UNITED STATES PATENT AND TRADEMARK OFFICE

APPLICATION NO.	FILING DATE	FIRST NAMED INVENTOR	ATTORNEY DOCKET NO.	CONFIRMATION NO.
10/763,630	01/24/2004	Russell Dennis	RD9-03-001	7726

Office Action Summary	Application No. 10/763,630	Applicant(s) DENNIS, RUSSELL	
	Examiner Michael P. Ferguson	Art Unit 3679

DETAILED ACTION

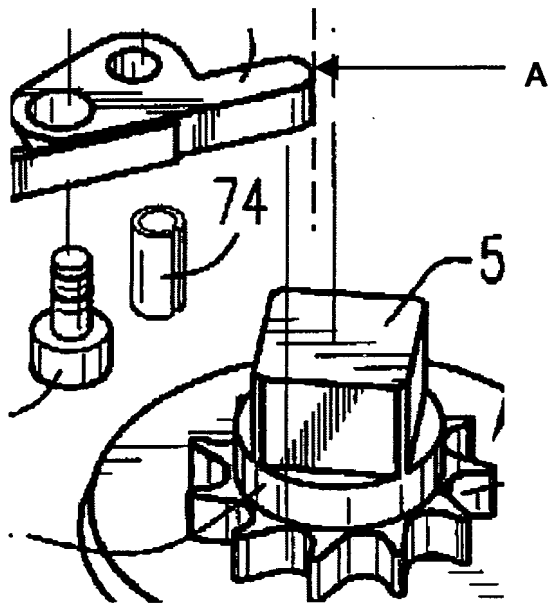
a pawl **70** supported on the body and rotationally movable to engage one end thereof with the tensioner;

a head **58,60** formed on the end of the tensioner for rotation thereof,

the pawl having an engaging end **A** (having a tangential end surface **A**) perpendicular to the pawl and engaging the surface of a portion of the tensioner, thereby blocking rotational movement of the tensioner;

a pair of pawls **70** each supported on the body and rotationally moveable to engage one end thereof with one of the tensioners, the pawl having an engaging end (having linear end surface **A**) perpendicular to the pawl, the engaging end further having a planer surface engaging an area on the surface of a portion of the tensioner thereby blocking movement of the tensioner,

each of the tensioners having a head **58,60** formed on the end thereof (Figures 4 and 6).

Examiner notes that a "planar" surface is defined as "a surface in which if any two points are chosen a straight line joining them lies wholly in that surface". Accordingly, all that is structurally required of a "planar" surface is that a linear surface is defined; clearly a linear contact surface exists along linear end surface **A** of the House et al. reference. If the applicant intends to recite an end surface which has both

Examiner disagrees. As to claims 1 and 8, as best understood, House et al. disclose a device wherein the pawl **70** has an engaging end **A** (having linear end surface **A**) perpendicular to the pawl, the engaging end further having a planer surface engaging an area on the surface of a portion of the tensioner, thereby blocking movement of the tensioner (Figures 4 and 6).

Examiner notes that a "planar" surface is defined as "a surface in which if any two points are chosen a straight line joining them lies wholly in that surface". Accordingly, all that is structurally required of a "planar" surface is that a linear surface is defined; clearly a linear contact surface exists along linear end surface **A** of the
